ADDENDUM NO. 1

Addendum Date: June 23, 2026

Project: Copperas Cove EDC 45 Acre Industrial Park

C12.2

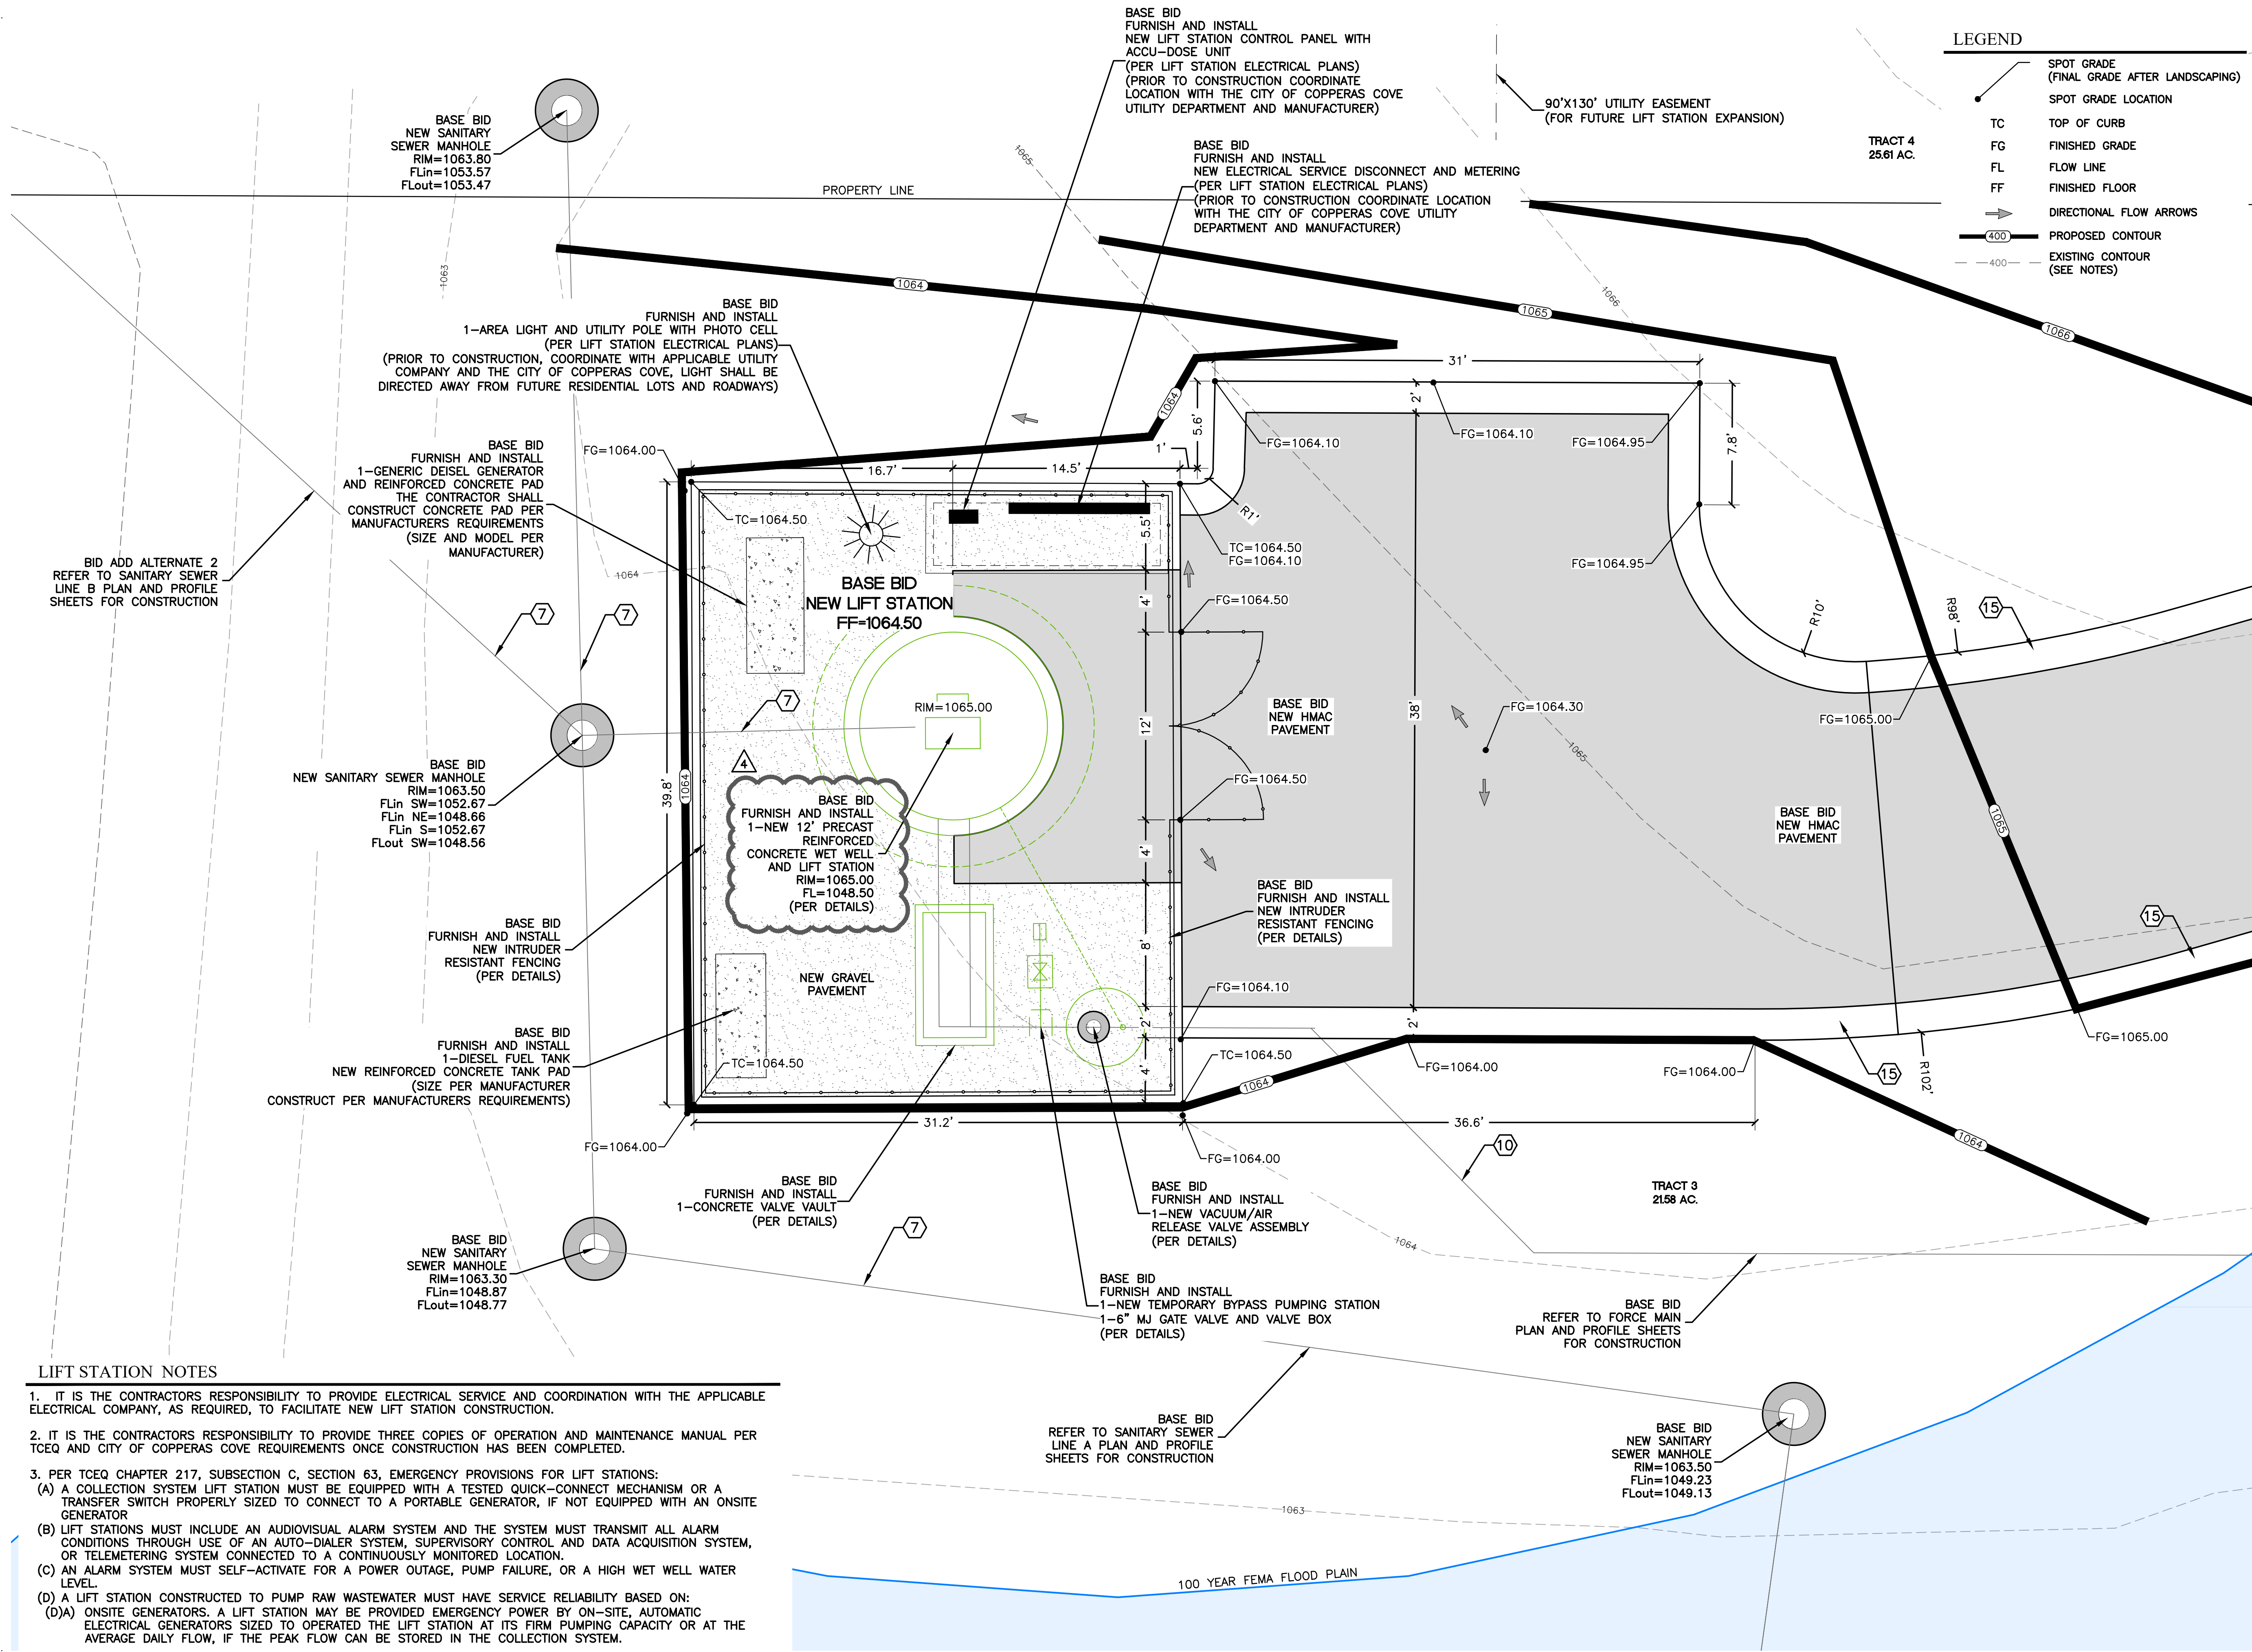
2. Sheet 97 (C12.2) calls for a 12' dia. Precast wet well. Sheet 104 (C14.2) calls for a 8' dia. Wet well. Which is correct? It is a 12' dia. wet well and the invert elevation for the flow in is 1048.50. Sheets C12.2 and C14.2 have been updated.

Item #3: Revised Sheet C12.2 provided.
